Service Bulletin No. 453D
(Supersedes Service Bulletin No. 453C)
Engineering Aspects are
FAA Approved

SUBJECT: Aluminum Push Rods P/N 73806 on O-235 Series Engines

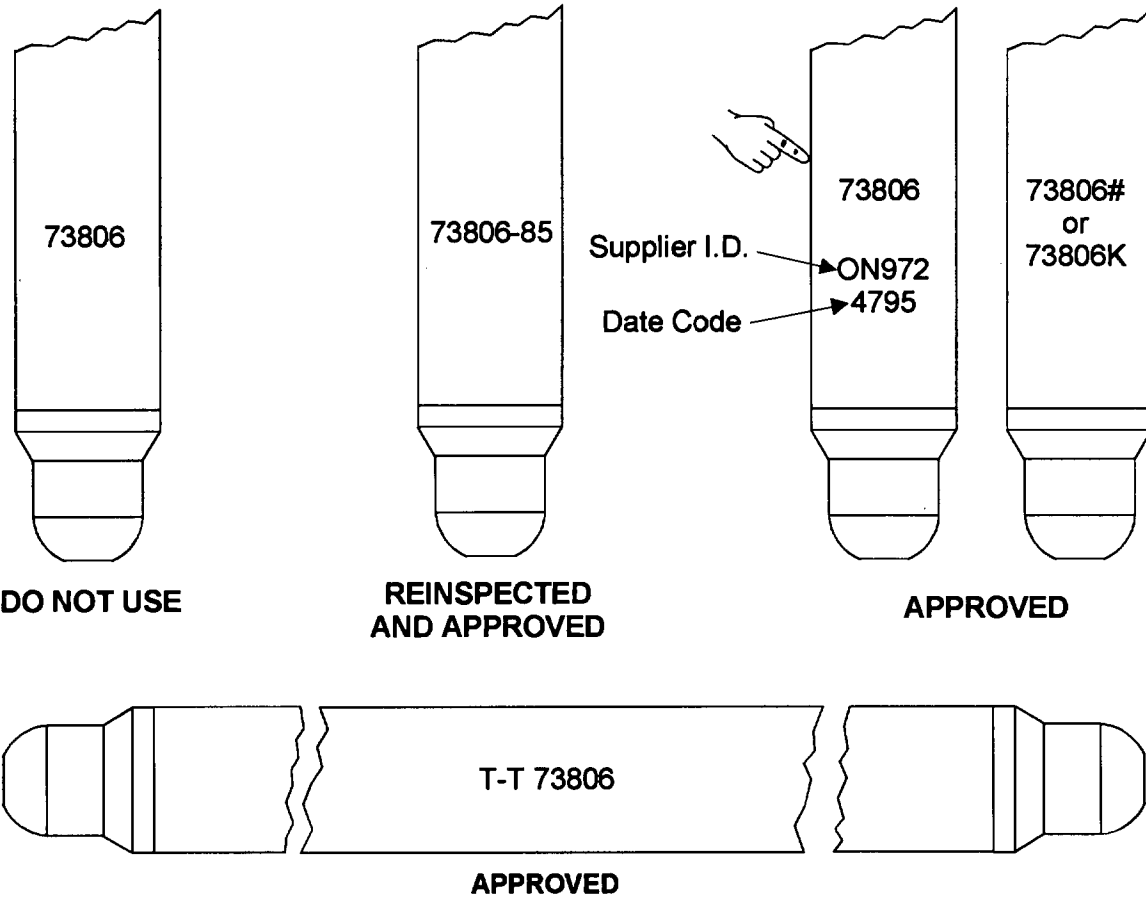
Use only push rods that are reinspected and marked with suffix -85; new push rods marked with a suffix # or K and subsequent, new push rods marked with supplier identification and date code, and push rods with a prefix T-T. See the accompanying illustration.

Push rods with the part number stamped in the center of the part and with the letters T-T as a prefix can be reinstalled.

NOTE: Revision "D" revises NOTE on page 2, and adds an approved push rod to the illustration.
